# 1990 Corvette: Service Bulletin: Clutch Apply Plate Material Changed to Powdered Metal

**Model and Year:** 1990 ALL CARS, TRUCKS, VANS WITH 4L60 (700-R4) AUTOMATIC TRANSMISSION

**Bulletin Number:** 90-189-7A - (03/06/1990)

The following dates show when changes went into effect: (Figure 1)

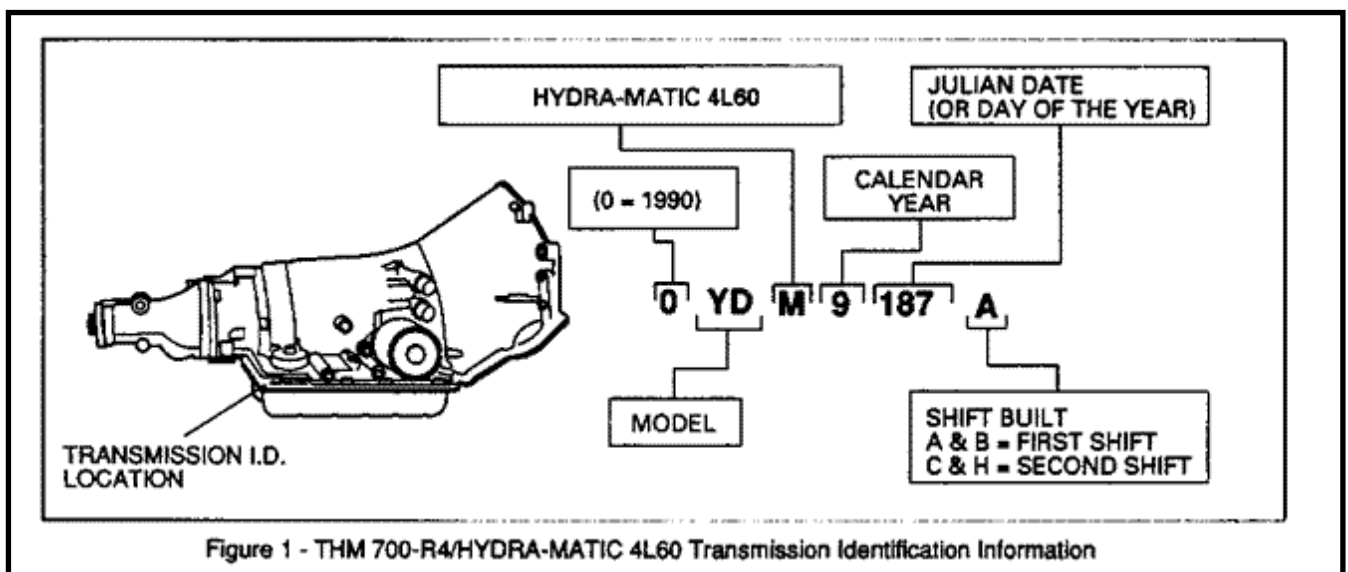
This bulletin covers a material change for the forward and 3-4 clutch apply plates. These clutches will now contain apply plates manufactured from powdered metal instead of steel.

Apply Plate Start of Production Date

Forward January 25, 1990 (Julian Date 025)

3-4 January 29, 1990 (Julian Date 029)

The new powdered metal plates are interchangeable with the current steel plates. Dimensions of the new powdered metal plates are the same as the steel plates. Powdered metal plates will appear darker in color than previously produced steel plates.

Part numbers have changed. (Figure 2)

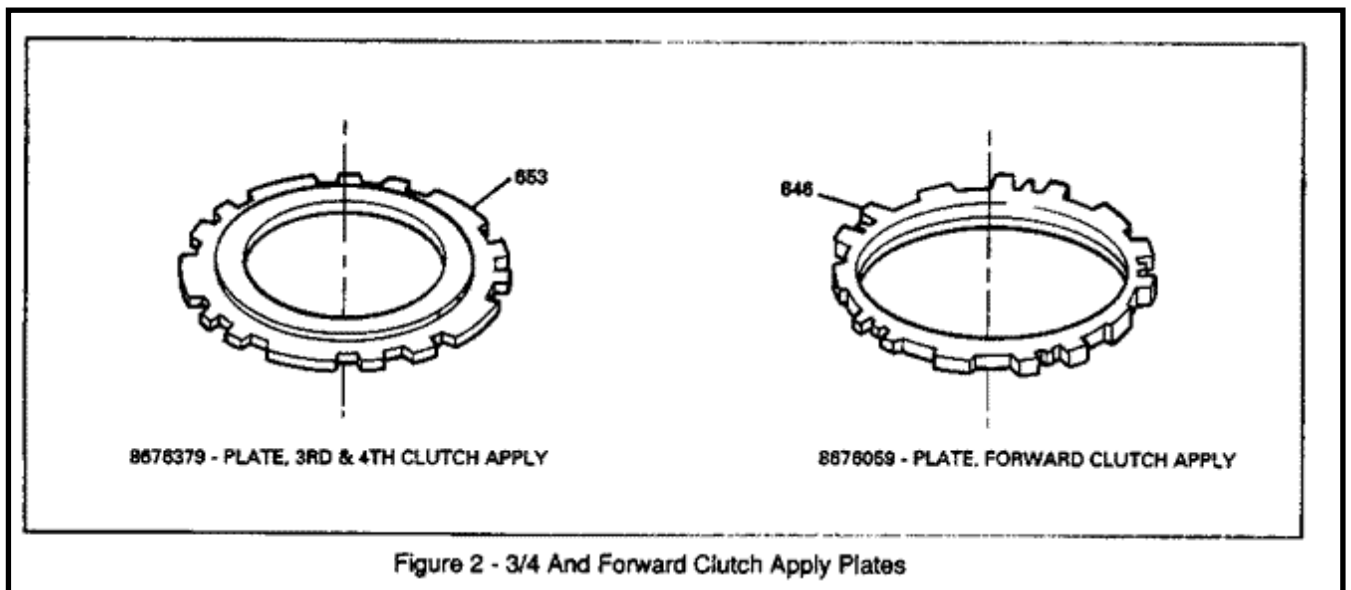
Part Number Description

8663785 Apply Plate - Forward Clutch (steel)

8667423 Apply Plate - 3-4 Clutch (steel)

8676059 Apply Plate - Forward Clutch (powdered metal)

8676379 Apply Plate - 3-4 Clutch (powdered metal)

When GMSPO stock of steel plates is used up, powdered metal plates will be available for service.
